#### ADDENDUM NO. 2

### ROUTE 580 SOUNDWALLS IN SAN LEANDRO PROJECT

Federal Project No. STPL-6273(052) ACCMA Contract No. A09-004

April 28, 2009

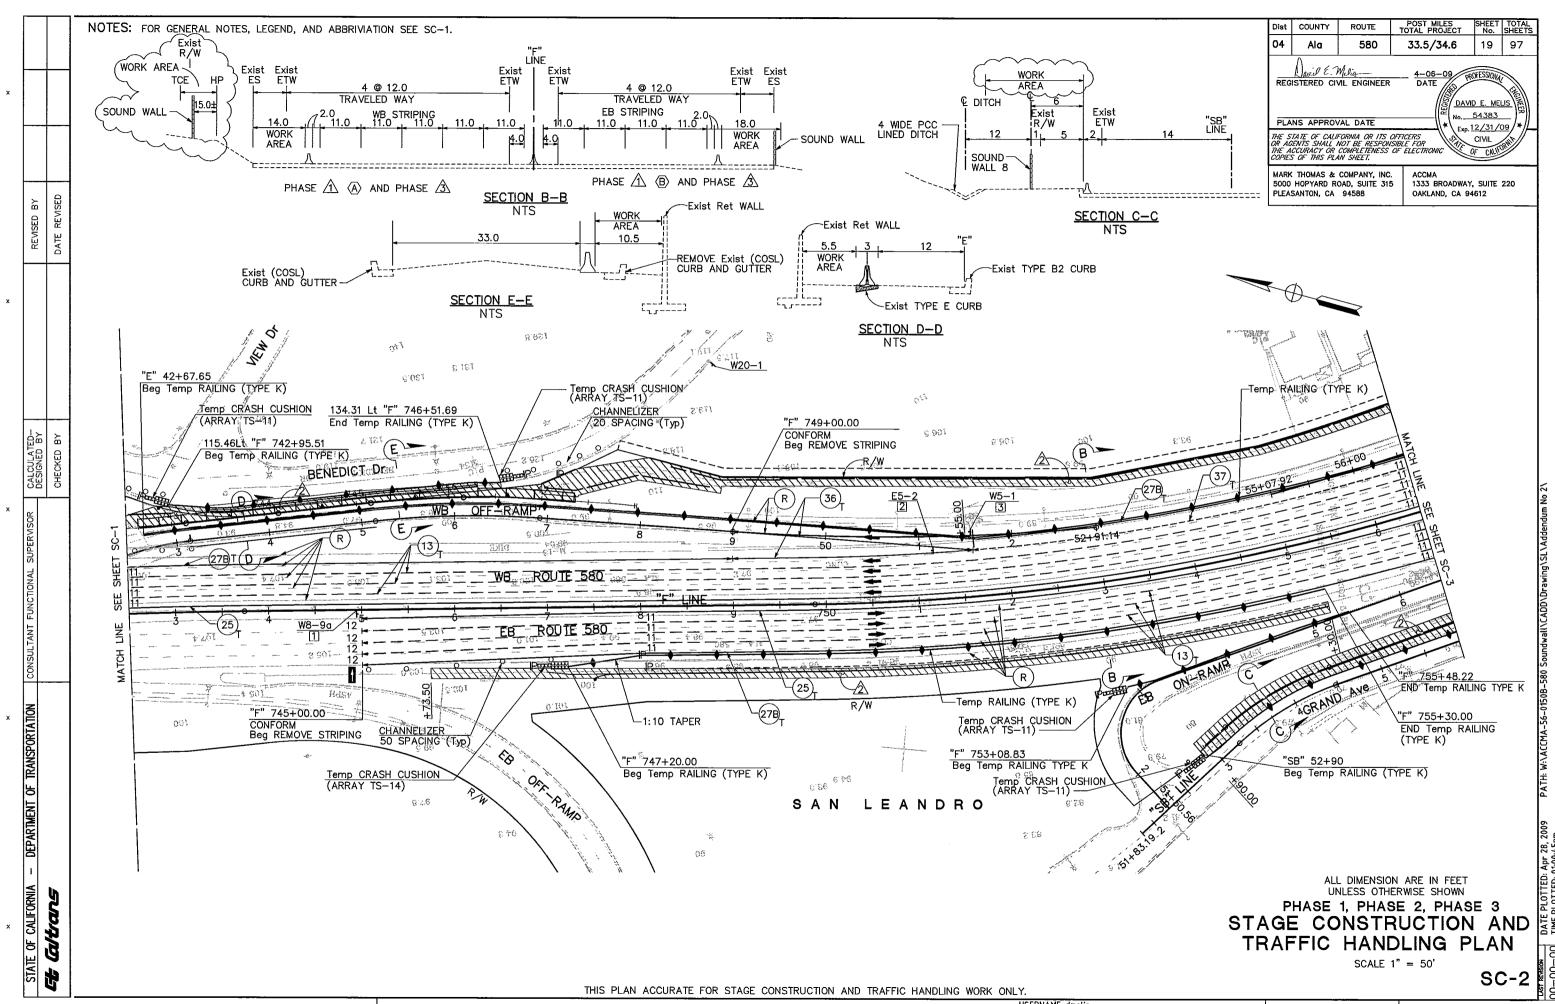
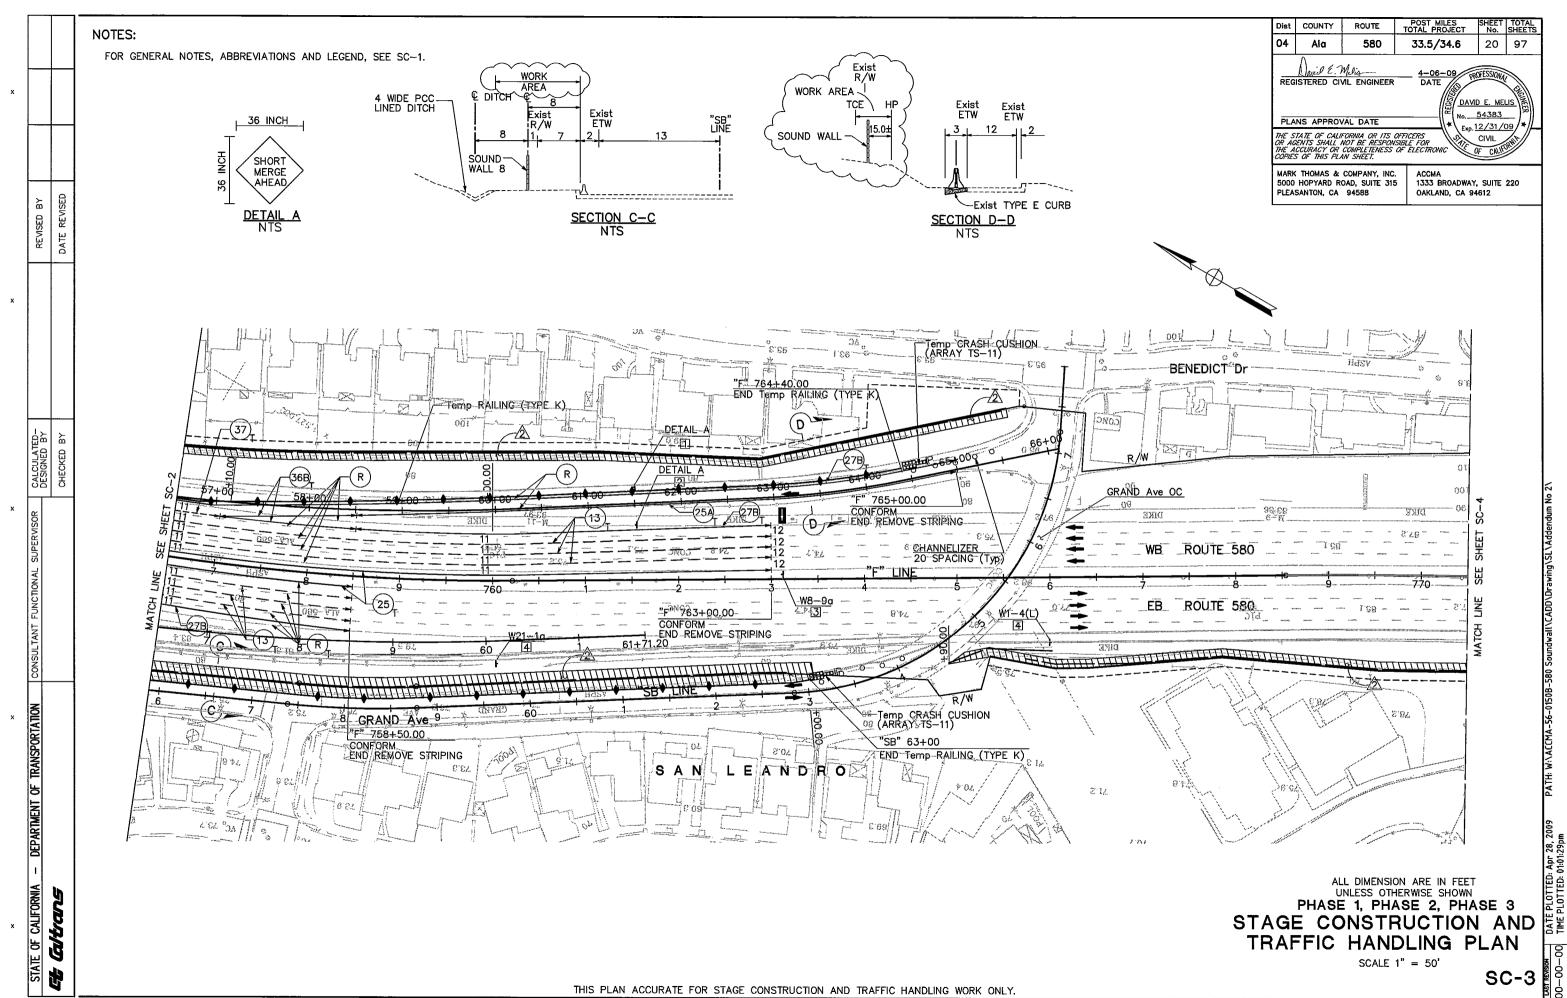
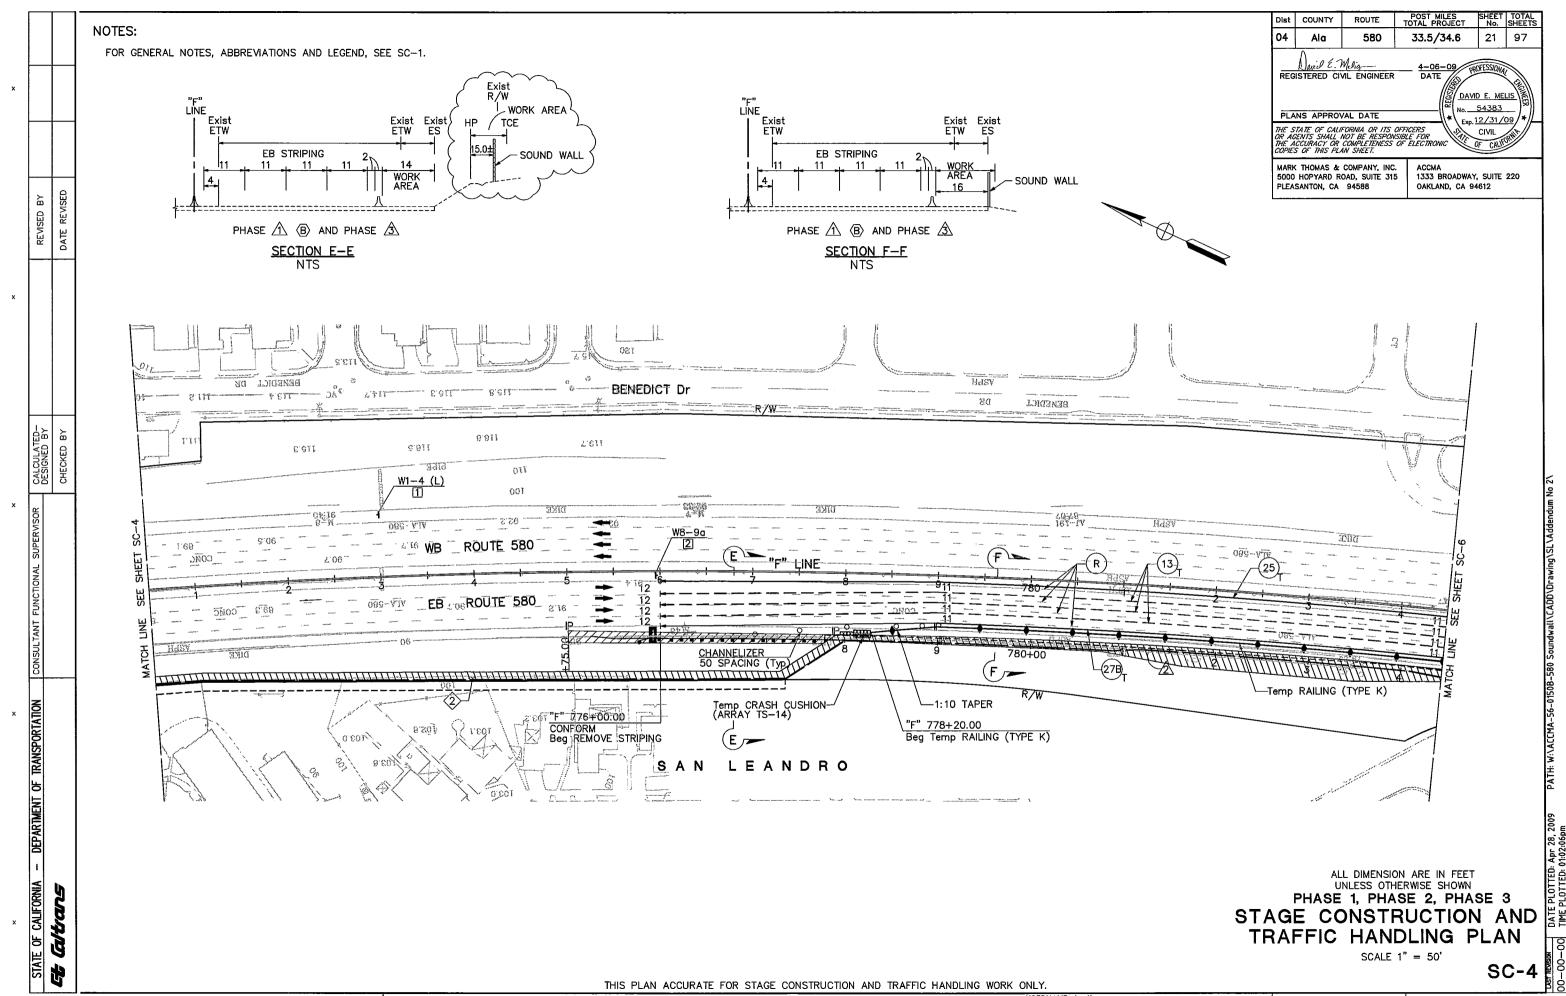
- 1) The Contractor's work areas along the right of way are clarified on the revised stage construction sheets SC-2, SC-3 and SC-4. (Attached)
- 2) Closure Chart No. 6 for Benedict Drive is added to the contract documents. (Attached)
- 3) Closure Chart No. 7 for Grand Avenue is added to the contract documents. (Attached)
- 4) Closure Chart No. 8 for Estudillo Avenue is added to the contract documents (Attached)
- 5) Specifications for staining the alternative sound wall system are added to the Special Provisions. (Attached)
- 6) Relocate Irrigation System (Bid Item 28) is removed as a bid item.
- 7) The bid item quantity for Temporary Mulch (Bid Item 5) shall be 410 CY.
- 8) Contract plan sheet SW-3 (Sheet No. 45), sheet SW-6 (Sheet No. 48), and sheet SW-34 (Sheet No. 76) are re-issued to reflect modifications to the wall heights and the dimension of the top block. (Attached)
